NUCLEAR REGULATORY COMMISSION

Title: ACRS US EPR Subcommittee

Date: November 15, 2011

Basic I&C Concept

DCS Physical Architecture

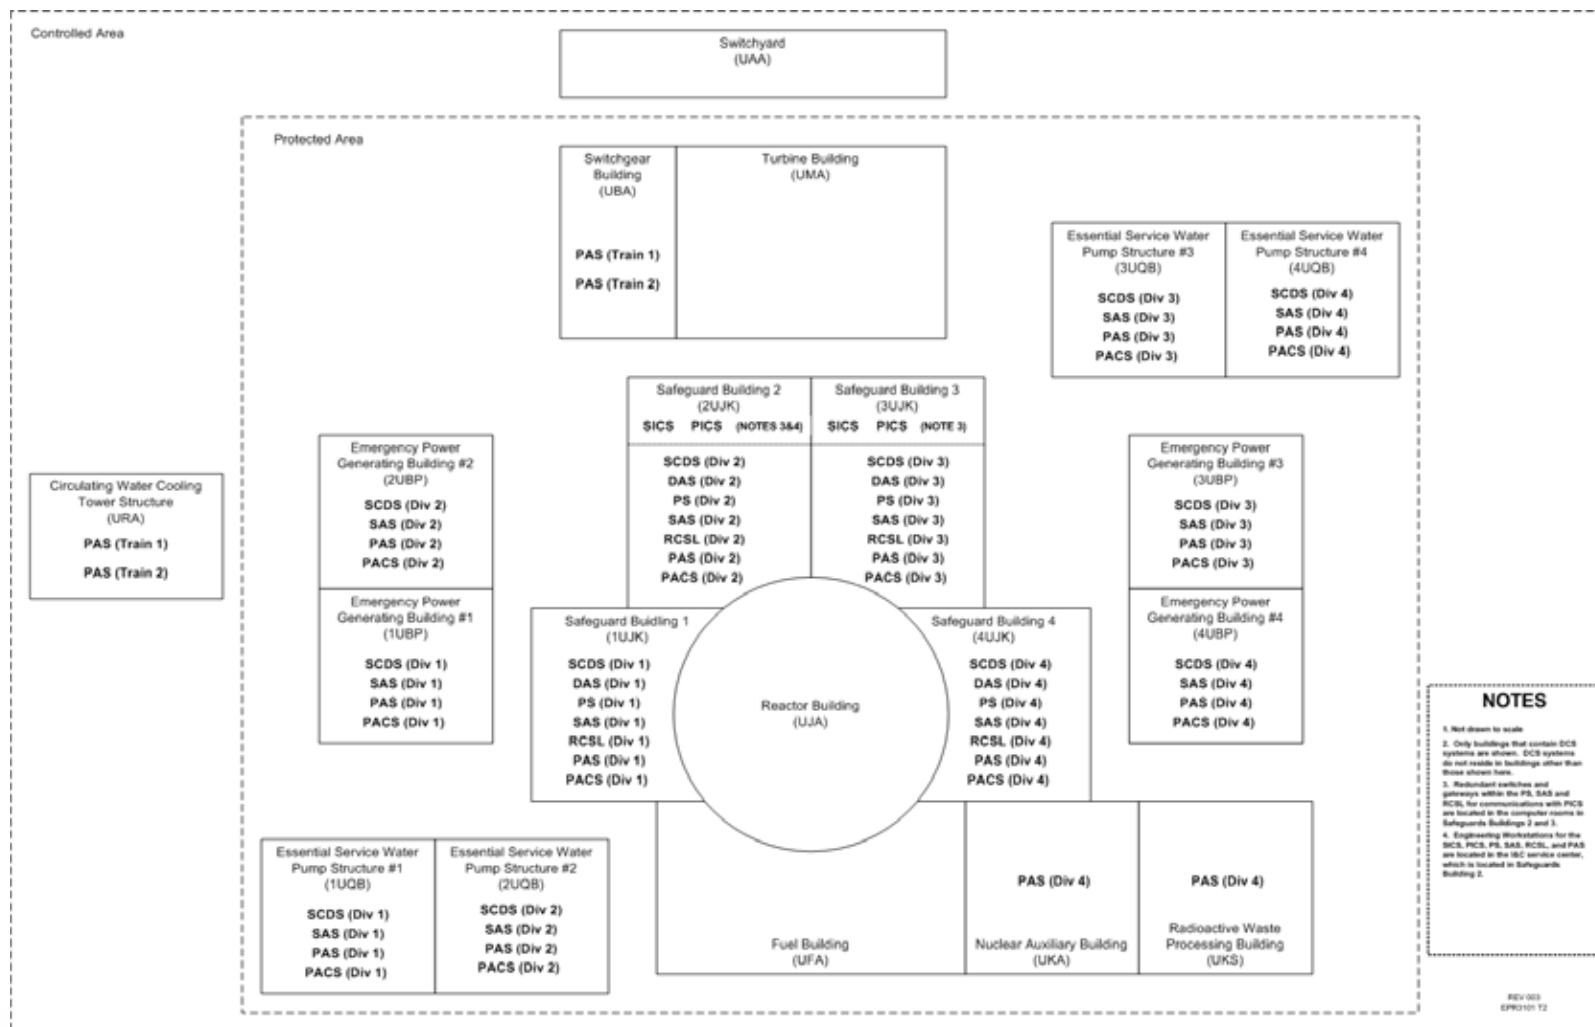
6 MEMBER STETKAR: And the little drawing
7 over there in the RSS box receives independent
8 signals from the servers. They don't come through.

18 MEMBER BROWN: The lines going to the
19 RSS, are those -- You don't show the server networks
20 going over towards to the RSS in the SICS
21 arrangement, relative to Protection System controls
22 limited. So are those dedicated lines or are they
23 still coming off the servers or the ability to
24 process?

1 From what I read, I didn't think any of
2 your protection system remote stuff went through the
3 PICS server network system. They go direct but I
4 couldn't figure that out based on -- I was hoping
5 that would be the case but it wasn't very explicit.

6 MR. SHOOK: That's correct. We'll get
7 into more in the further sections. But the PICS
8 cannot send signals to the protection system in SAS.

Redundancy

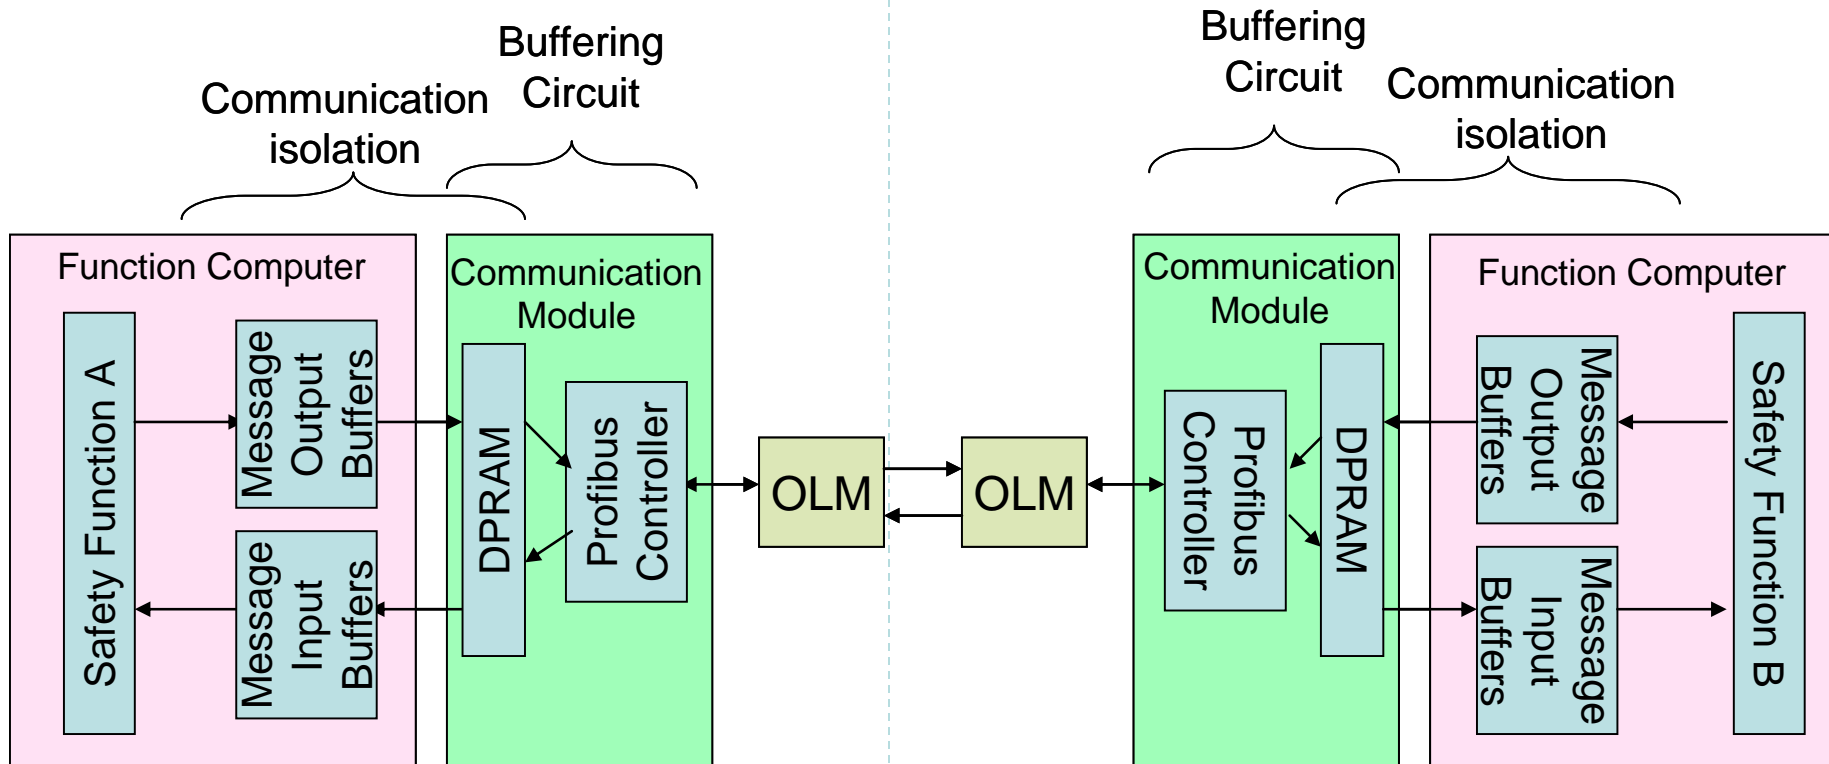
- **SICS, ICIS, EIS, BCMS, RMS, HMS, SCDS, and RPMS**
 - Sufficient level of redundancy: ITAACs
- **Safety Automation System (SAS)**
 - Four redundant, independent SAS divisions
 - Open Item: How does SAS voting logic compensate for single failures within a division? (RAI 505, Question 07.01-36)
 - Open Item: Applicant to provide a FMEA (RAI 505, Question 07.01-35)

Independence

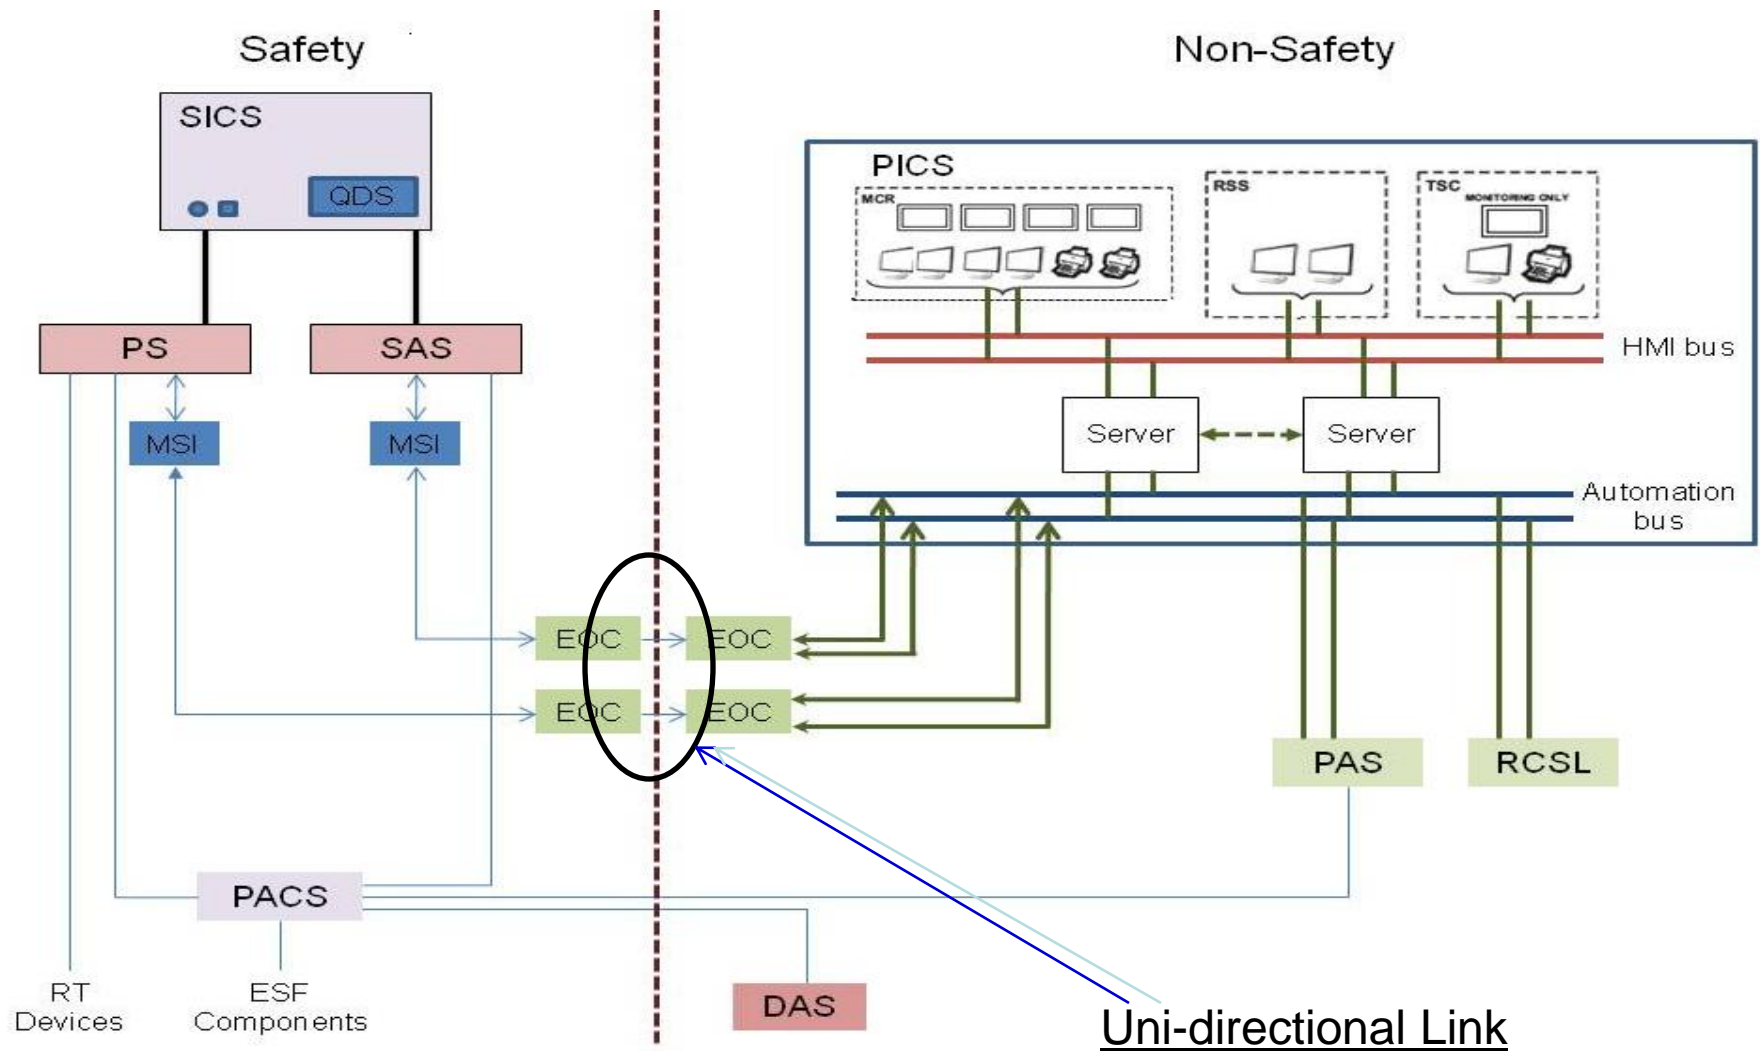
- **Accommodation of SPND Single Failures:**
 - Detection of failures and use of setpoint modification for detected failures
 - Conservative setpoint selection within each PS division to accommodate a single, undetected failure upstream of the PS
 - Open Item: Applicant to submit necessary revisions to Chapter 15 accident analysis and documentation for events crediting use of SPNDs. (RAI 505 Question 07.01-33)

Self-Testing Open Items

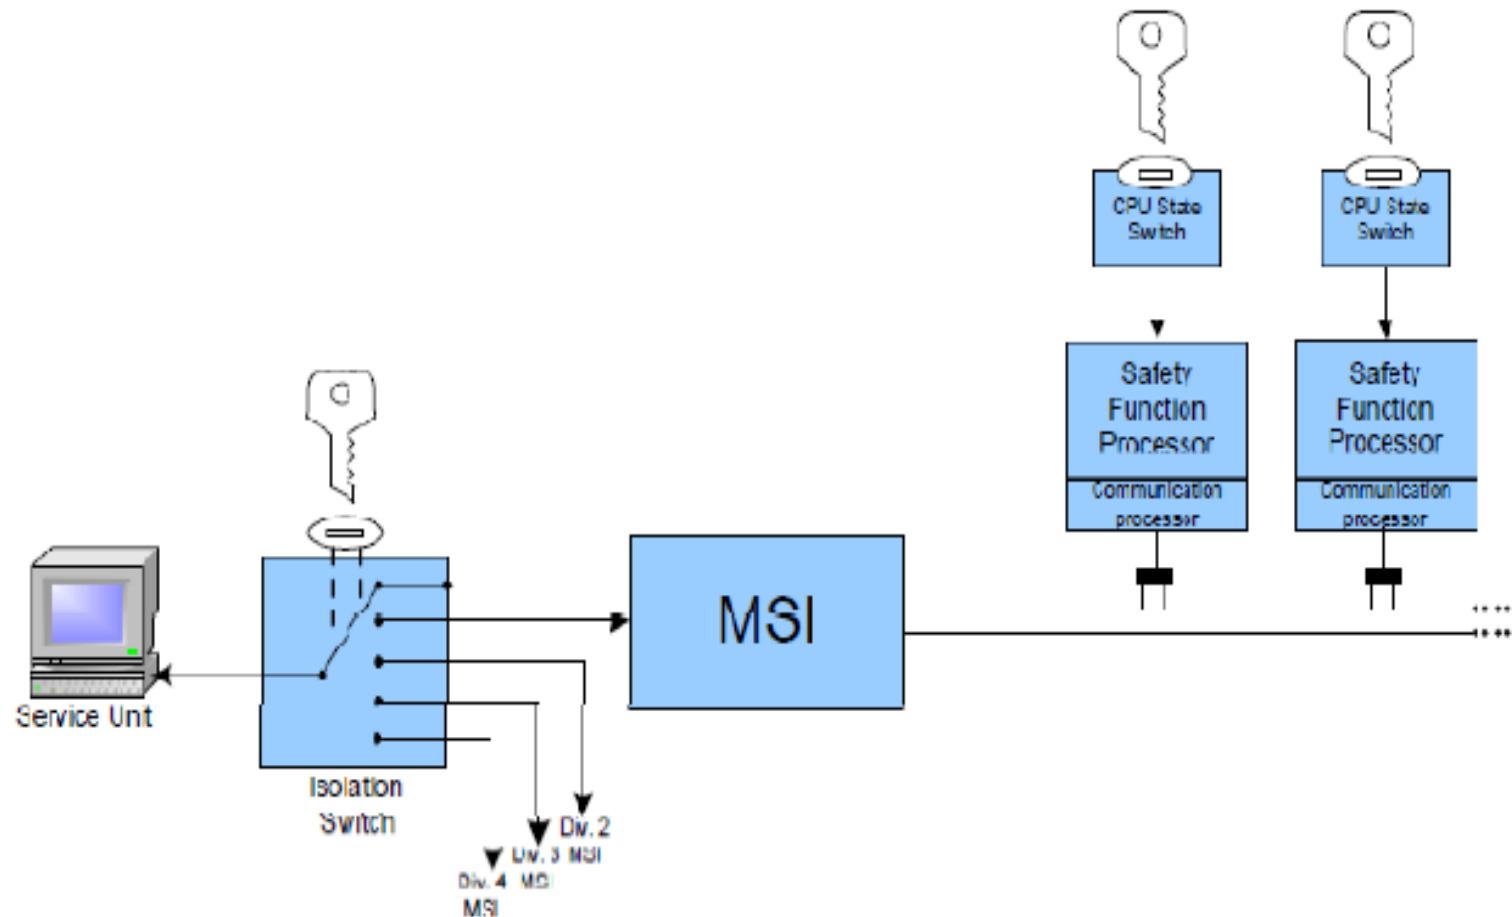
- **TXS Self-Testing and Surveillance Testing**
 - Verification of Self-tests: How is automated self-testing periodically verified? (RAI 505, Question 07.01-39)
 - How is operability addressed for detect failures and failures of the self-test functions itself? (RAI 505, Question 07.01-40)
